**TRANSMITTAL LETTER
FOR
SERVICE BULLETIN NMD-28-16 Rev 1**

**CUSTOMER OPTION G28 AND G28A SELF-SEALING FUEL TANKS - ADDITIONAL
SUPPORT (MOD N625 PARTS A AND C)**

CUSTOMER OPTION G28 AND G28A SELF-SEALING FUEL TANKS - ADDITIONAL SUPPORT (MOD N625 PARTS A AND C)

Figure 1 Rework of Fuel Tank Bay Vent Pipes

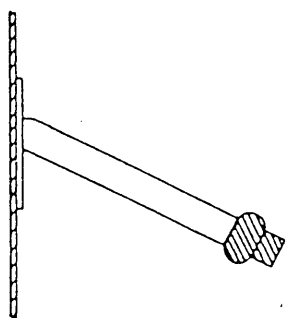
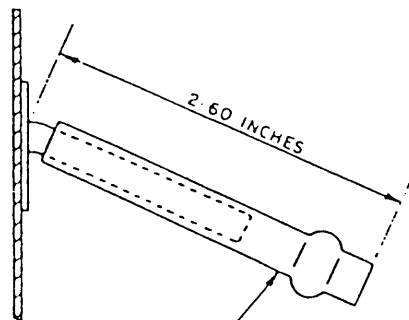
C. **Mod N625A Part 1 - Rework the Fuel Tank Bays Vent Pipes (Ref Fig 1).**

- (1) Using a small pipe cutting tool or hacksaw, cut off the pipe beading at each of the 16 tank vent pipes (four at each tank bay).
- (2) Deburr and smooth each cut end of the vent pipes using a small file.
- (3) Remove all cadmium plating from the straight section of each vent pipe using a fine grade abrasive paper. Clean and degrease the abraded sections of the vent pipes with LOCQUIC T PRIMER. Do not permit the primer to contact any internal surface of the pipe.
- (4) Clean and degrease both internal and external surfaces of the vent pipe extension tubes (PN 1A/N-03-787) with either LOCTITE 15 QUICK CLEAN or trichloroethane solvent.
- (5) After ensuring that the primer has completely evaporated from the external surfaces of the vent pipes, select one vent pipe extension tube and coat the inner surface of the non-beaded end

- (6) Select one of the vent pipes and coat the previously abraded and primed surface with LOCTITE RETAINING COMPOUND GRADE 620. After ensuring that the entire surface is completely wetted with compound, carefully slide the coated end of the wetted extension tube over the coated section of the vent pipe. Locate the beaded end of the extension tube at 66 mm (2.6 in) from the tank wall and immediately twist the extension tube through 180 degrees while maintaining the 66 mm dimension.

- (7) Allow approximately 30 minutes for the LOCTITE to partially cure then check the jointing between the vent pipe and extension tube for complete fill and satisfactory adhesion.
 - (8) Using a pull-through wetted with the solvent used in step (4), remove all traces of LOCTITE RETAINING COMPOUND from the internal and external surfaces of the vent pipe and extension tube.
 - (9) Repeat steps (4) to (8) inclusive for each of the remaining tank vent pipes.
 - (10) Apply zinc chromate primer or suitable alternative to all exposed abraded surfaces of the tank vent pipes.
 - (11) Check all vent tubes are clear.
- D. **Mod N625A Part 2 - Installation of Additional Tank Lacing Brackets in Fuel Tank Bays (Ref Fig 2).**

Part 1 - Provides modified or reworked vent pipes which are lengthened to give increased space for fitting the clamp on the tank vent pipe between the pipe bead and the tank inner wall.

Figure 2 Installation of Additional Lacing Brackets

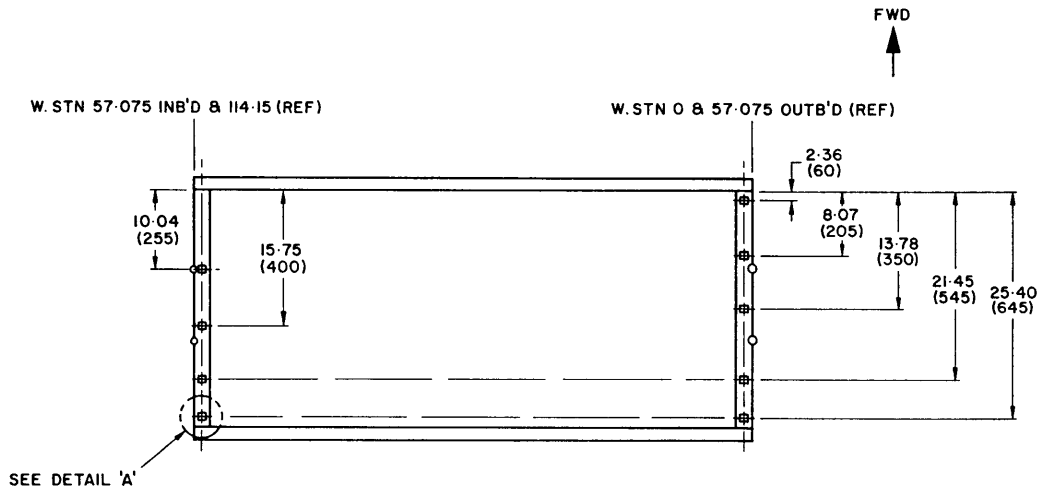
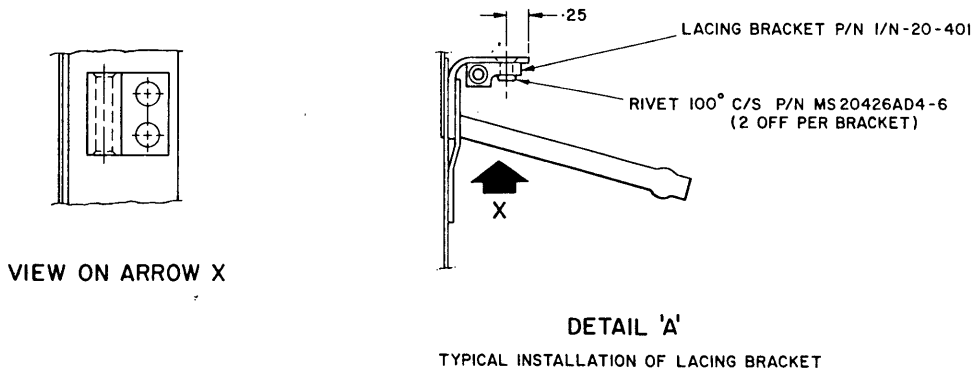
- (1) At 72 locations (Ref Fig 2) drill No 30 (3.3 mm) dia holes, countersink (100 deg) and deburr, for additional tank lacing brackets.
- (2) Install 36-off additional tank lacing brackets, PN 1/N-20-401 in fuel tank bays. Wet assemble brackets using pigmented chromate jointing compound and rivet with 72-off countersunk rivets PN MS20426AD4-6. Refer to Figure 2 for installation details.
- (3) Clean off excess jointing compound and touch up bare metal surfaces as required with zinc chromate primer.

Part 2 - Provides nine additional lacing brackets for each tank bay to improve the tank support at the ends and relieve the strain on the vent pipes.

Figure 3 Installation of Additional Preformed Support Loops

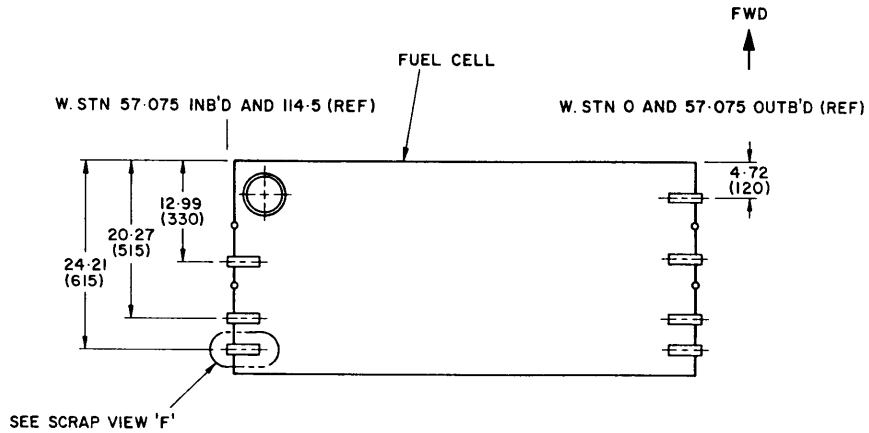
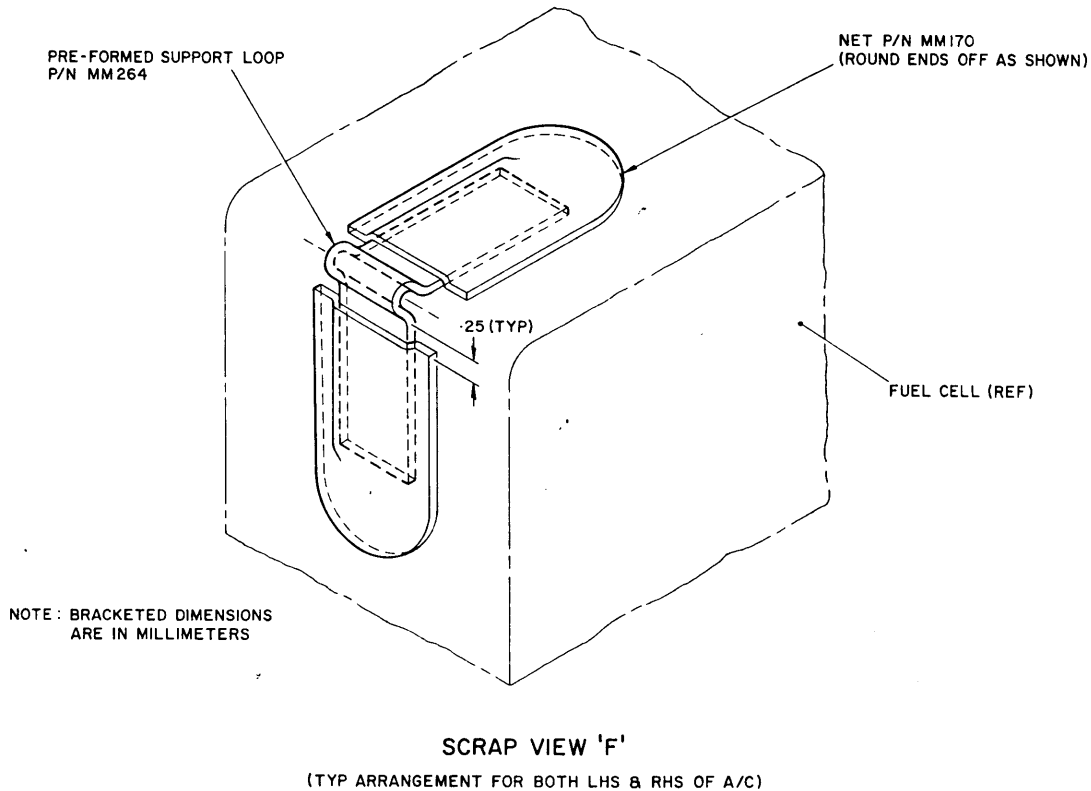
E. Mod N625C - Installation of Additional Support Loops and Vent Pipe Moulding Reinforcement to Fuel Tanks (Ref Fig 3).

- (1) Locate positions of additional support loops as shown in Figure 3 and remove the paint from the tank for a sufficient area to allow the support loop and the net to bond directly to the reinforcing fabric on the tank.

- (2) Coat the bared tank fabric and the buffed face of the support loop with two coats of adhesive BOSTIK 2762 or GOODYEAR 80 C29, allowing the first coat to dry before applying the second coat.

When the second coat is almost dry, apply the cord support loop to the tank, ensuring that a 6mm dia bar can be passed through the loop, then firmly press the legs of the loop to the tank.

- (3) Repeat step (2) at remaining support loop positions and then apply net patches by cementing and stippling through.
- (4) All areas of the tank reinforcing fabric where paint has been removed (Ref step (1)) and is still exposed after fitment of the support loops and net patches are to be covered by two coats of adhesive to prevent ozone attack.
- (5) Lightly buff around the outside diameter of the vent pipe moulding, then apply two coats of adhesive to the buffed areas and also to the buffed face of the 1/2 in x 2 1/2 in reinforcing strip PN MM169, allowing the first coat to dry before applying the second coat.

When the second coat is almost dry, wrap the rubber reinforcing strip around the vent moulding, cementing the outside of the strip where it overlaps onto itself, and retain in position until dry.

This part provides modified or reworked self-sealing tanks incorporating seven additional lacing loops together with fabric reinforcing applied to the vent pipe moulding.
